MIL-L-6363/8
Amendment 1
3 September 1993

MILITARY SPECIFICATION SHEET

LAMPS, INCANDESCENT AIRCRAFT SERVICE, SINGLE CONTACT, MIDGET FLANGED BASE T-1 3/4 BULB

This amendment forms a part of Military Specification sheet MIL-L-6363/8 dated 25 September 1992, and is approved for use by all Departments and Agencies of the Department of Defense.

Requirement 14 marking.

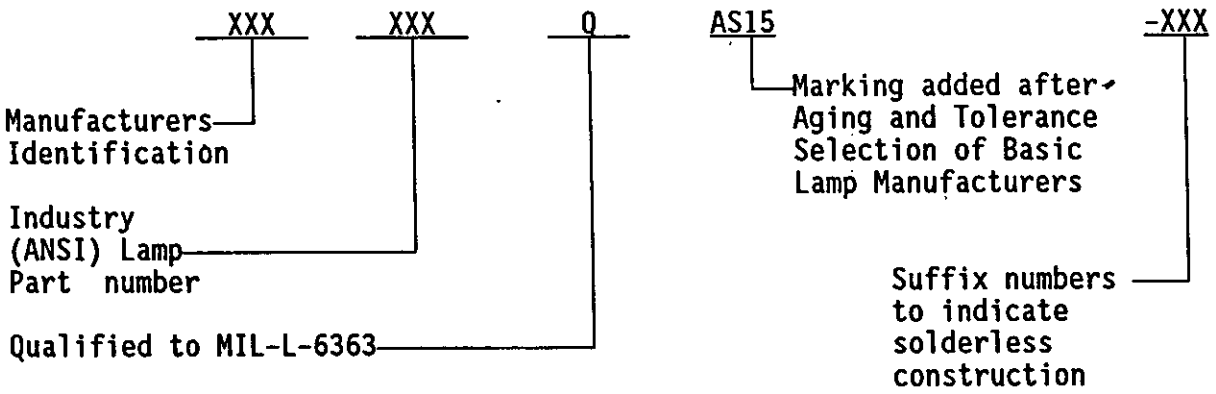
Delete - "To be determined for marking of production lamps," and rest of paragraph.

Substitute the following:

"14. Marking. Production lamps qualified to MIL-L-6363 and listed on QPL-6363 shall be marked in accordance with ANSI/NEMA C78.390 and as supplemented herein. ANSI/NEMA C78.390 authorized suffix letters shall be supplemented with the letter "Q" (MIL-L-6363 QPL item). The letter "Q" shall be incorporated into the method of designation in accordance with the preferred marking below.

EXAMPLE

Preferred Marking

Alternate Acceptable Marking

Where marking area is limited by base size, length or size of marking, or where pre-marked bases are used, the letter "Q" may be marked on any convenient space on the base.
